**FINAL EXPRESS TERMS
FOR
PROPOSED BUILDING STANDARDS
OF THE
DEPARTMENT OF HOUSING AND COMMUNITY DEVELOPMENT
REGARDING PROPOSED CHANGES TO THE 2007 CALIFORNIA BUILDING CODE (CBC)
CALIFORNIA CODE OF REGULATIONS, TITLE 24, PART 2
(HCD 02/07)**

The Department of Housing and Community Development (HCD) proposes to make necessary changes to the 2007 edition of the California Building Code (CBC), based on the 2006 International Building Code (IBC), as presented on the following pages. HCD further proposes to:

FIGURE 11A-6A—WARNING STRIPING AND HANDRAIL EXTENSIONS

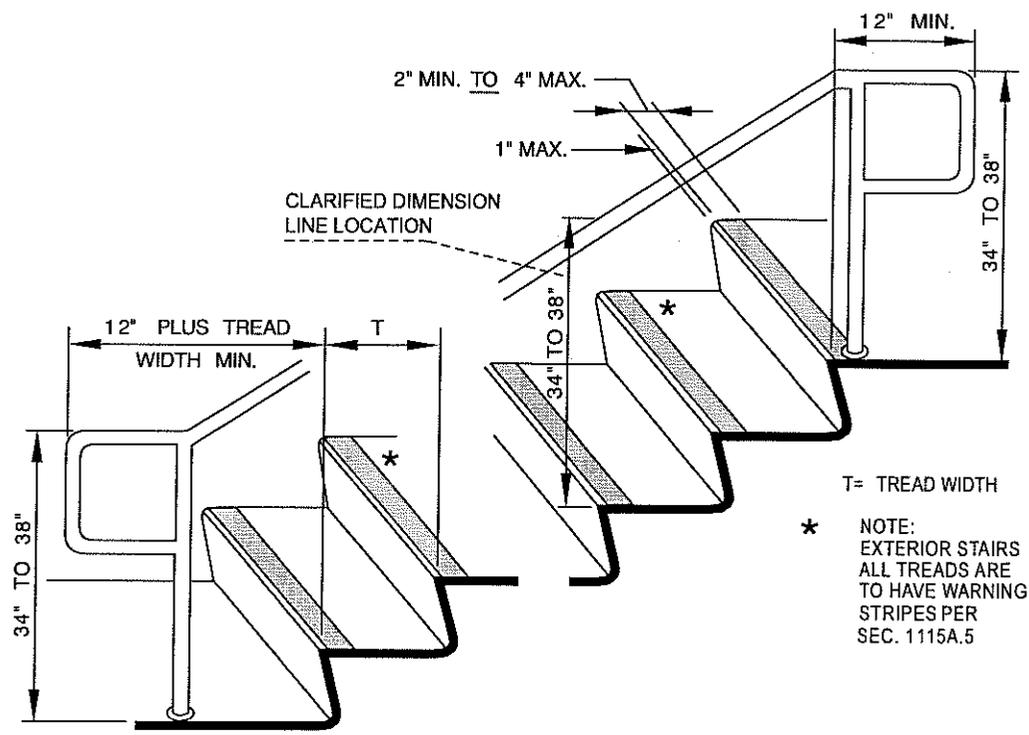
33. Amend Figure 11A-6A “WARNING STRIPING AND HANDRAIL EXTENSIONS”:

Figure 11A-6A (see attached)

1115A.4 Nosing. Nosing shall not project more than ~~1 1/4~~ 1 1/4 inches (38.4 31.8 mm) past the face of the riser below. Risers shall be sloped or the underside of the nosing shall have an angle not less more than 60 30 degrees (0.52 rad) from the horizontal vertical. (See Figure 11A-6A).

1123A.4 Nosing. Nosing shall not project more than $1\frac{1}{4}$ inches (31.8 mm) past the face of the riser below. Risers shall be sloped or the underside of the nosing shall have an angle not less more than 60 30 degrees (0.52 rad) from the horizontal vertical. (See Figure 11A-6A).

1123A.6.2.3 Handrail extension. Handrails shall extend a minimum of 12 inches (305 mm) beyond the top nosing and 12 inches (305 mm), plus the tread width, beyond the bottom nosing. Where the extension creates a hazard, the termination of the extension shall be rounded or returned smoothly to floor, wall or post. Where the stairs are continuous from landing to landing, the inner rail shall be continuous and need not extend out into the landing. (See Figures 11A-6A and 11A-6E).

FIGURE 11A-8J – PLATFORM AT SECONDARY EXTERIOR DOOR

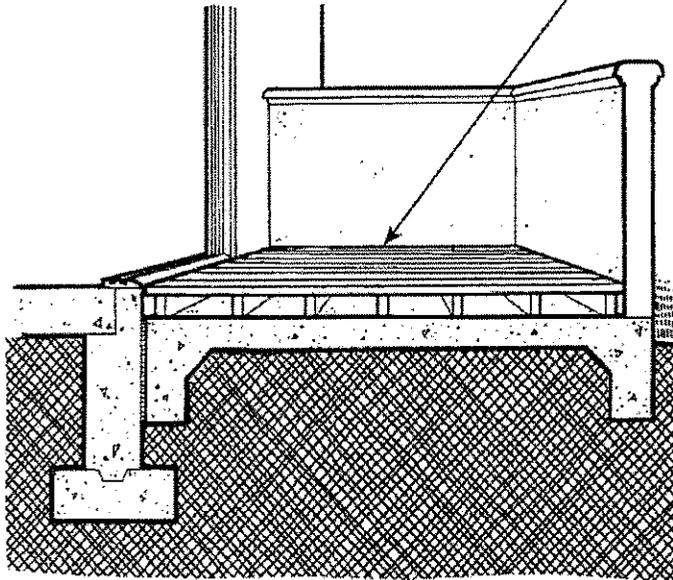
34. Add Figures 11A-8J, 11A-8K, 11A-9L and 11A-9M:

Figures 11A-8J “Platform at Secondary Exterior Door”; 11A-8K “Ramp at Secondary Exterior Door”; 11A-9L “Shower with Water Closet”; and 11A-9M “Wing Wall or Cabinet at Water Closet” are added (see attached.)

3. Secondary exterior doors onto decks, patios or balcony surfaces constructed of impervious materials (e.g., concrete, brick, flagstone) may have a maximum change in height from the interior landing of 4 inches (101.6 mm). Changes in height greater than ½ inch (12.7 mm) shall be accomplished by means of a ramp complying with Section 1114A or by means of a platform constructed to the level of the floor as illustrated in Figure 11A-8J.

*Platform of approved materials to raise
floor level of balcony.*

(Platform required for final inspection)
